2. COMMON RESPONSES TO RECURRING COMMENTS

2.1 EIR/EIS ADEQUACY AND PURPOSE

Figure 2.7-1. Spectral Content of Vestas V80 Noise Showing Infrasonic and Low Frequency

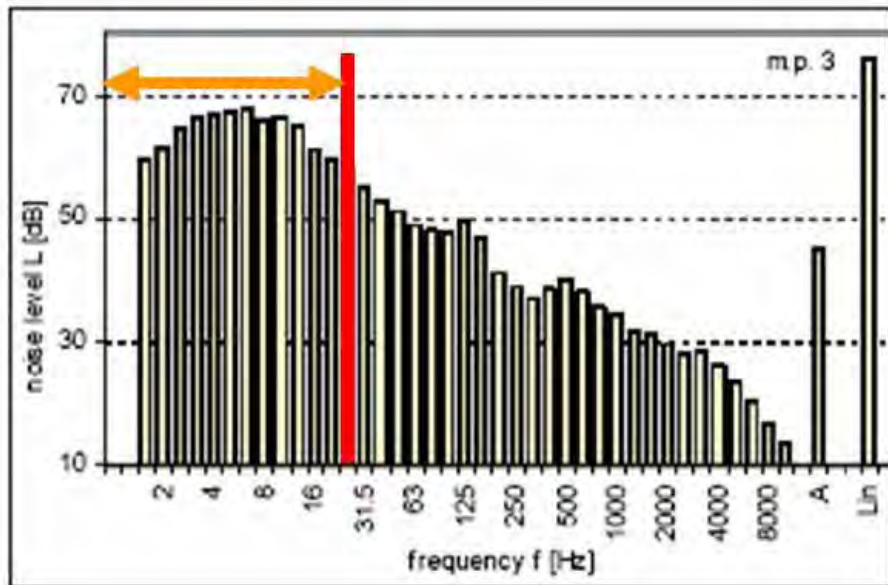
An example of infrasound and low-frequency sound downwind of a Vestas V80 wind turbine is shown in Figure 2.7-1. The infrasonic and low frequency content of the Vestas noise emissions are below the hearing human perception threshold. The Vestas V80 frequency spectrum is similar but several dB less than the worst-case wind turbine used for the Tule Wind Project.

Figure 2.7-2. Wind Turbine Noise Measurement Data

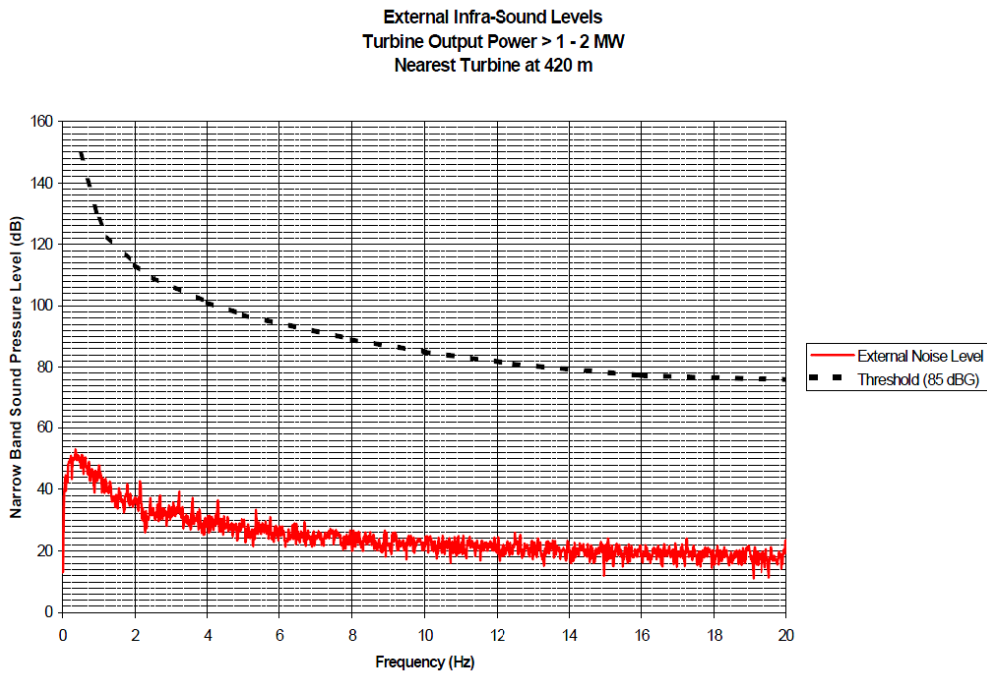
The data in Figure 2.7-1 are supported by data reported in “InfraSound, Low Frequency Noise, and Vibration from Wind Turbines” by Dr. Andy McKenzie of the Hayes McKenzie Partnership Ltd, as shown in Figure 2.7-2. The data in Figure 2.7-2 shows that infrasound from a 1 to 2 MW wind turbine operating approximately 420 meters away from the receiver are well below the threshold for perception of infrasound.

Figure 2.7-3. Infrasound Summary Results from Two Australian Wind Farms

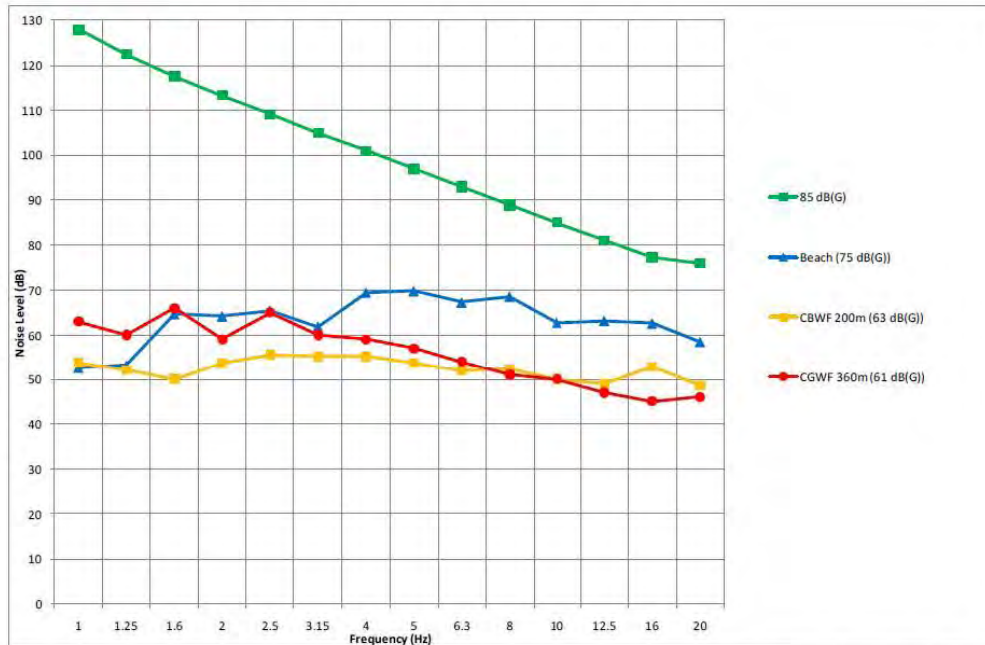
The Sonus measurement results indicate that the levels of infrasound in the vicinity of the two Australian wind farms are well below the audibility threshold of 85 dB(G) established by international research. The measurement results are of the same order as that measured from a range of sources, including a beach.
